SHEARON HARRIS NUCLEAR POWER PLANT, UNIT 1
DOCKET NO. 50-400 / RENEWED LICENSE NO. NPF-63

**SUBJECT: RESPONSE TO REQUEST FOR ADDITIONAL INFORMATION (RAI)
REGARDING APPLICATION FOR EMERGENCY OPERATIONS FACILITY
(EOF) CONSOLIDATION**

Attachment 1
RA-16-0035

Response to NRC Request for Additional Information

FIGURE B-11
OCONEE NUCLEAR STATION
Common EOF - Multi-Site Event Staffing

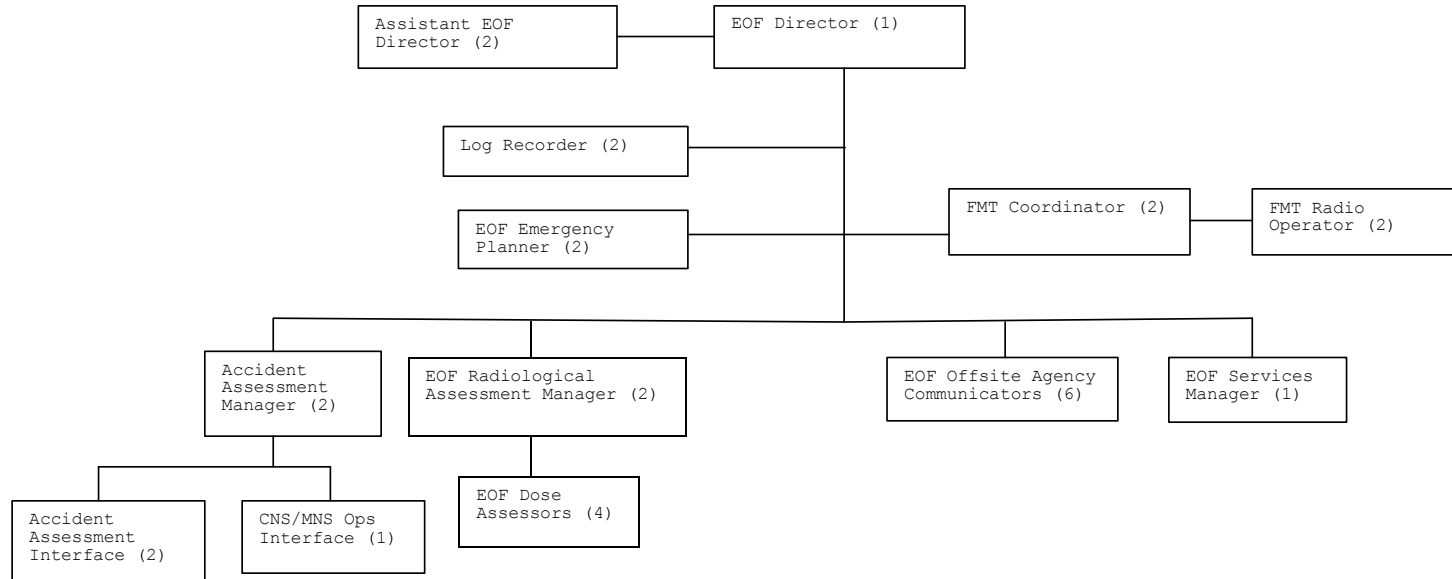
On August 2-3, 2016, the NRC staff performed a walk down of the Duke Charlotte EOF. During the NRC staff's walk down, it was verbally indicated to the staff that the facility could support a simultaneous response for events at more than two sites. As identified above, Duke Energy describes processes and protocols for accommodating simultaneous responses at up to two sites. Please describe facility capabilities and what process and protocols have been established to support accommodating simultaneous responses at more than two sites. Include how Duke would further staff the facility, establish command and control, and effectively coordinate event response during multi-site simultaneous events.

The Charlotte EOF was designed with the physical capabilities (e.g. space, equipment, etc) to support simultaneous responses for up to three sites. As Duke Energy has not committed to (and is not committing to in this response) supporting events at more than two sites simultaneously, a formal process for this scenario has not been established. However, with regard to staffing, command and control, and coordination, the Charlotte EOF would expand from two to three sites in a corresponding manner as the existing process for expanding from one to two sites (see Figure B-11 below from the ONS Emergency Plan, which shows the EOF organization for a two site event). The normal EOF staff complement would be augmented with

additional personnel as needed, particularly for those positions which could not reasonably perform their responsibilities for multiple sites. The EOF Director would assume overall responsibility, whereas there would be an Assistant EOF Director for each affected site. The main EOF area contains three segregated areas each with its own equipment (e.g. computers, phones, wall displays) to support the EOF functions for each affected site. The rooms surrounding the main EOF area with major support functions (e.g. offsite communications, radiation assessment, accident assessment, offsite monitoring) also include separate space and equipment for up to three sites. Since sufficient space and equipment is available for the key positions to support three simultaneous events, each position would be able to follow their normal process for completing their responsibilities. Furthermore, visual aids such as color coding would be used to differentiate staff for the different sites. Finally, as stated in Section 3.1.1 of the subject license amendment, the Technical Support Center (TSC) will serve as a backup to the EOF. This would allow the flexibility of the TSC for any of the sites to perform the EOF functions. This could be for the duration of the event or the responsibilities could be transferred between facilities as needed, likely depending on event severity.
